REMARKS

This is intended as a full and complete response to the Office Action dated June 15, 2004, having a shortened statutory period for response extended two months set to expire on November 15, 2004. Please reconsider the claims pending in the application for reasons discussed below.

IN THE DRAWINGS:

Fig. 3B

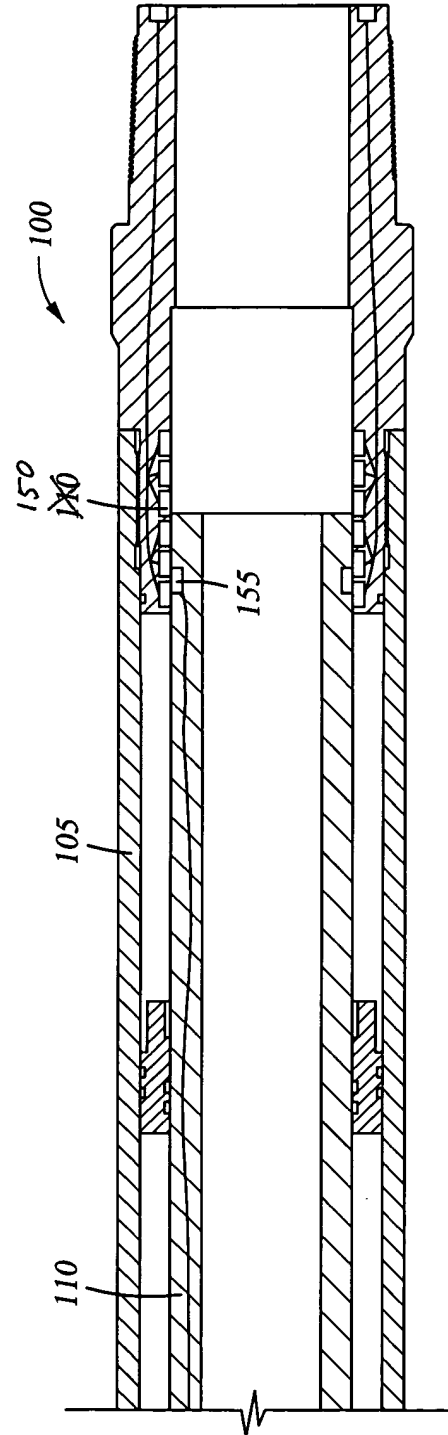
The drawings stand objected to under 37 C.F.R. § 1.83(a) for failure to show the claimed element "sensor." Applicants propose amendments to the drawings to correct minor editorial problems and to overcome the objection under 37 C.F.R. § 1.83(a). Applicants have submitted the proposed corrections marked in red on the attached copies of the original drawings filed in the application. The proposed corrections conform the drawings to the written description of the invention. The proposed amendment to Figure 3B renumbers previously mislabeled element 150. The proposed amendments to Figure 4 entail insertion of omitted labels 110 and 105. The proposed amendments to Figures 5A and 5B entail insertion of omitted label 100 and a labeling correction for previously mislabeled element 175. The proposed amendment to Figures 6a and 6B entails insertion of omitted label 100. The proposed amendment to Figure 7A entails insertion of omitted label 217. The proposed amendment to Figure 9 entails insertion of omitted label 100. The proposed amendments to Figures 11A and 11B entail deletion of extraneous label 80 and insertion of previously omitted labels for sensor 98 and vibrator 99. The sensor is described in the specification in paragraphs [0037], [0045], [0046], [0048], and [0050]. The vibrator is described in the specification in paragraph [0051]. Accordingly, Applicants submit that the proposed amendments do not introduce new

The attached sheets of drawings include changes to Figure 3B, Figure 4, Figure 5A, Figure 5B, Figure 6A, Figure 6B, Figure 7A, Figure 9, Figure 11A, and Figure 11B, and replace the original sheets including Figure 3B, Figure 4, Figure 5A, Figure 5B, Figure 6A, Figure 6B, Figure 7A, Figure 9, Figure 11A, and Figure 11B.

Attached are 7 sheets of formal drawings showing the abovementioned changes and a marked-up copy of the original sheets. Please amend and admit Figures 3B, 4, 5A, 5B, 6A, 6B, 7A, 9, 11A, and 11B as shown in the attached sheets.
